DATE: 7.30.2018
TO: ProTrak
FROM: Bill McDow
 Transportation Planning

■ **MAYFAIRE SELF DEVELOPMENT [TRC Plan Review]**

↻ Initial Review Note ↻

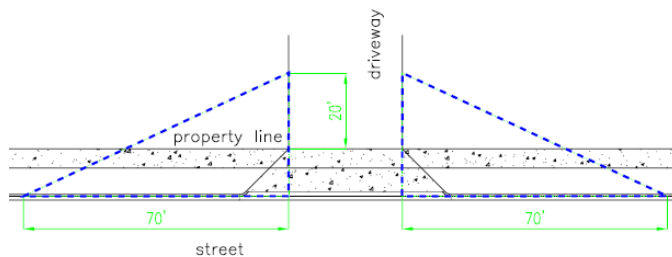
- The site plans do not show the parking spaces assigned for these restaurants. 90 parking spaces were listed in the site data table, however, most of the parking spaces are not shown on the site plan.
